**PLANNING COMMISSION  
SITE PLAN REVIEW SHEET  
APPEAL OF AN ADMINISTRATIVE DENIAL**

**CASE NUMBER:** SP-2016-0196C **COMMISSION DATE:** 01/10/2016

**PROJECT NAME:** 2010 South Lamar Office

CITY OF AUSTIN – DEVELOPMENT SERVICES DEPARTMENT  
SITE PLAN APPLICATION – MASTER COMMENT REPORT

#### **2.2.2. Core Transit Corridors: Sidewalks**

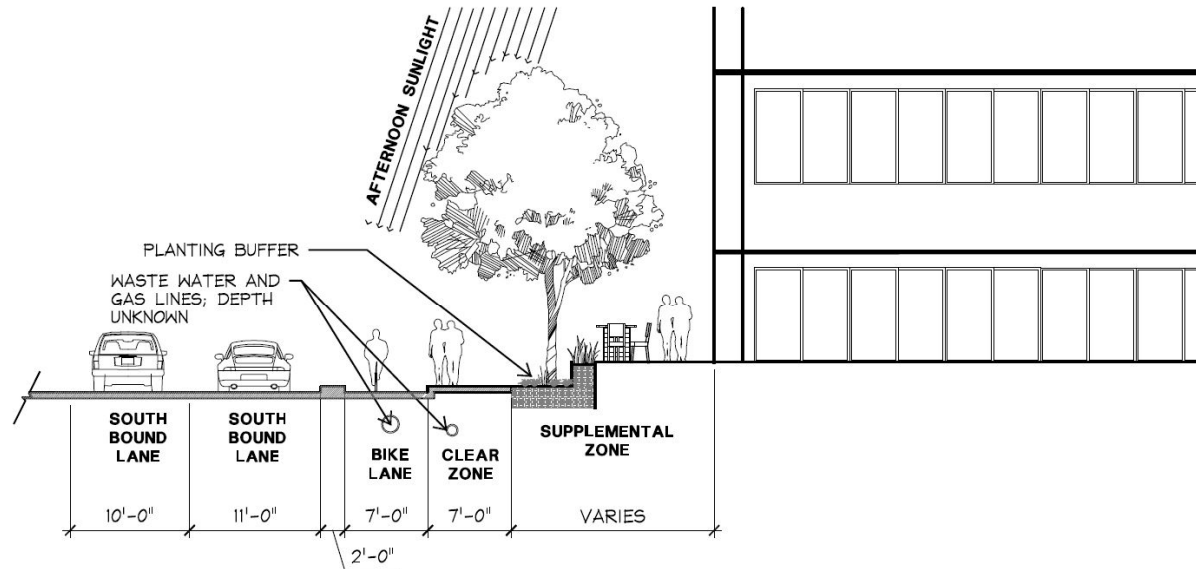
- (B1) Planting zone - "The planting zone shall have a minimum width of eight feet (from face of curb) and shall be continuous and located adjacent to the curb...The zone shall be planted with street trees at an average spacing not greater than 30 feet on center."
- (B2) Clear Zone. "The clear zone shall be a minimum width of seven feet, shall be hardscaped, shall be located adjacent to the planting zone..."

Your site is constrained by the presence of a Wastewater Line directly adjacent to the ROW, which would prevent the planting of trees in the required planting zone. AEC is sought in order to provide bike lanes and maintain a shaded sidewalk away from the wastewater line.

- A 2 foot curb, a separation from traffic
- A 7 foot bike lane
- A 7 foot clear zone
- A variable (18 – 20 feet) supplemental zone, planted with trees an average of 30 feet on center

**STREETSCAPE OPTION A - SHADE TREES IN SUPPLEMENTAL ZONE WITH DETACHED BIKE LANE IN ACCORDANCE WITH LAMAR BLVD CORRIDOR PLAN**

**SUBJECT:** Neighborhood Traffic Analysis for 2010 South Lamar Office  
Site Plan# SP – 2016 – 0196C.

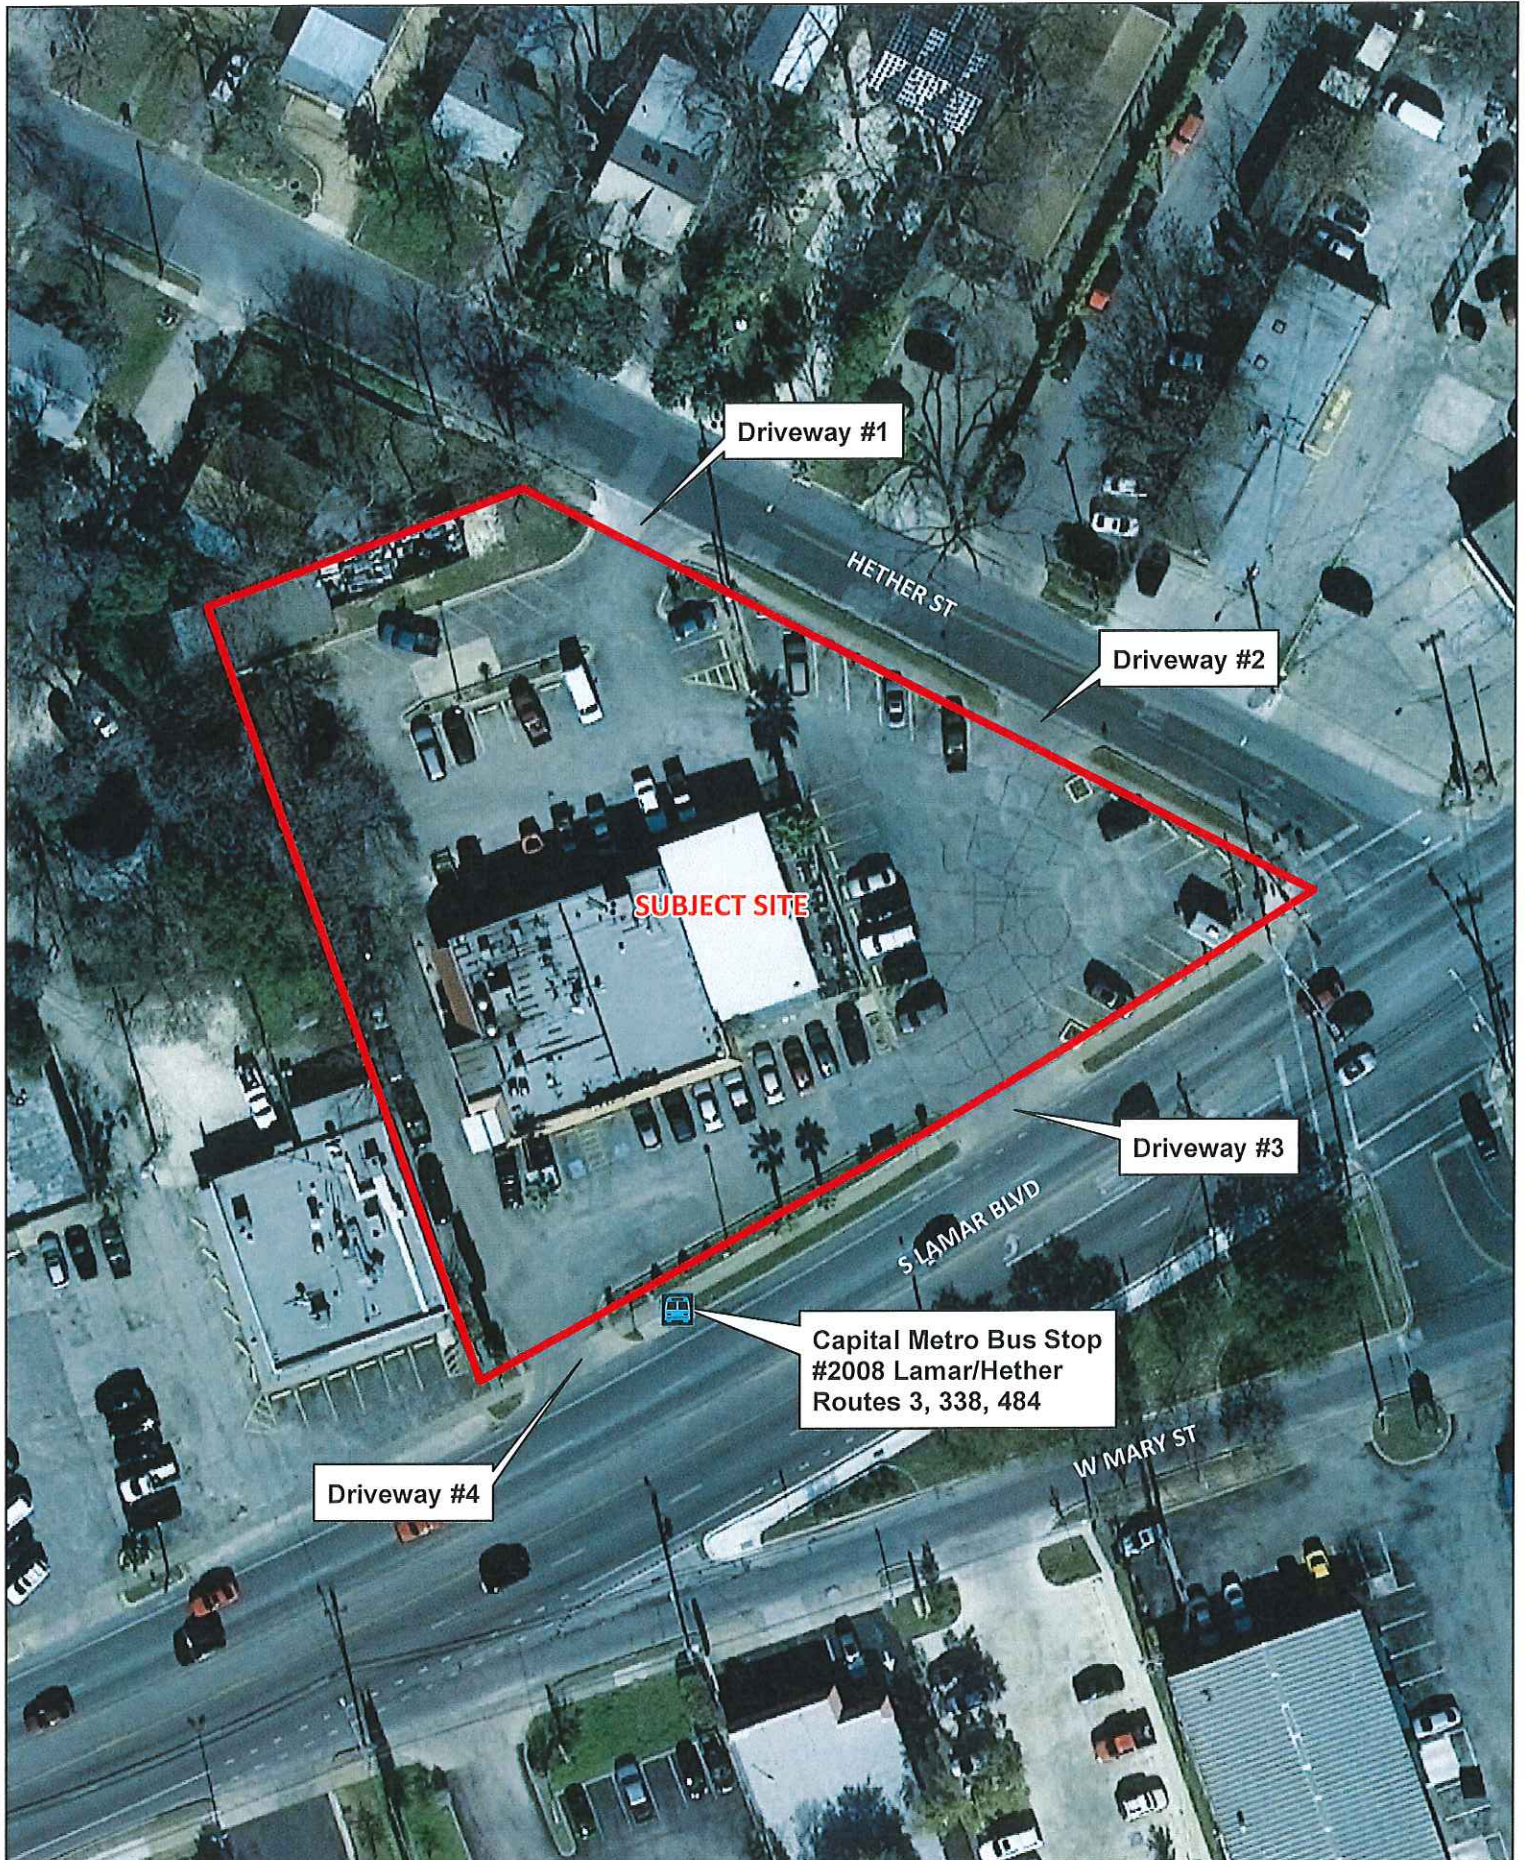
The sole point of vehicular access to the site is from Hether Street, therefore, in accordance with the LDC, staff recommends denial of this site plan application as it would exceed the permitted total daily volumes for residential streets.

1. The potential trips generated by this site, in combination with the existing traffic of Hether Street, and Kinney Avenue, exceeds the thresholds set forth in the LDC 25-6-116. Therefore, staff recommends denial of this site plan application.
